DEVELOPMENT REVIEW BOARD REPORT

MEETING DATE: January 27, 2005

CASE NUMBER/ PROJECT NAME	5-DR-2003#3 Rug Gallery West		
LOCATION	14939 N Northsight Blvd.		
REQUEST	Request site plan & elevations approval for a retail building on Pad D in the Northsight Crossing Center.		
OWNER	Northsight Crossing LLC 702-784-7665	ENGINEER	Gilbertson Engineering 480-607-2244
ARCHITECT/ DESIGNER	S K D Inc 602-999-3140	APPLICANT/ COORDINATOR	Steve Kim S K D Inc 602-999-3140

SITE PLAN

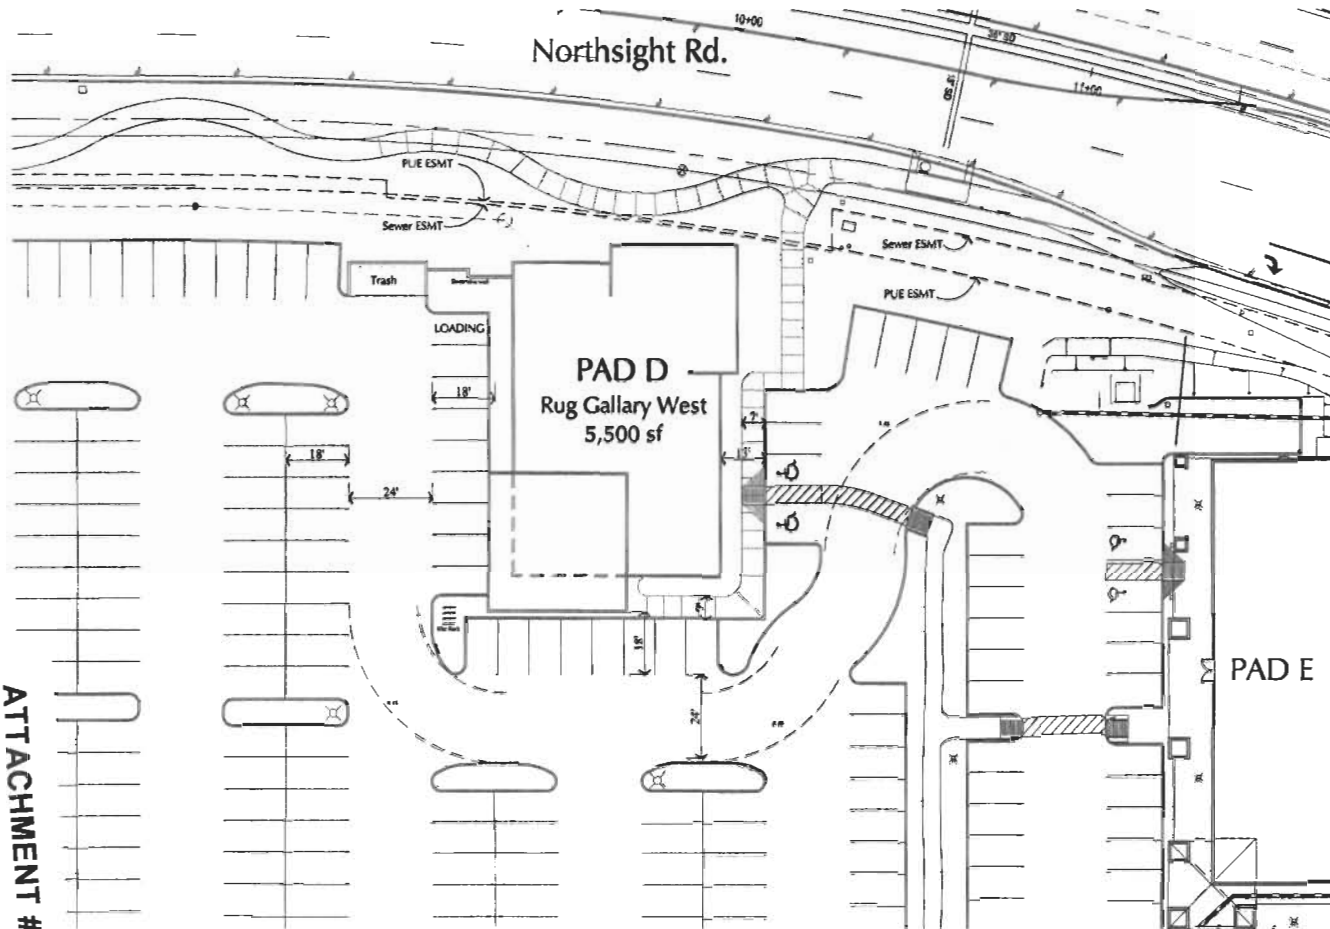
12. Any transformers for the proposed building shall be screened on three sides by a wall meeting the requirements of stipulations elsewhere herein. The unscreened side shall be located and oriented to minimize visual exposure while maintaining required public utility company access. The open side shall not be visible from Northside Blvd or the east.

29. The final plans shall show a pedestrian connection from parking areas to the building.
30. The position of the parking stalls adjacent to Northsight Blvd. shall be modified so that they would not be at an acute angle with the parking stalls to their south.
31. The developer shall provide a minimum parking-aisle width of 24 feet.
32. The developer shall provide internal circulation that accommodates emergency and service vehicles with an outside turning radius of 45 feet and inside turning radius of 25 feet.
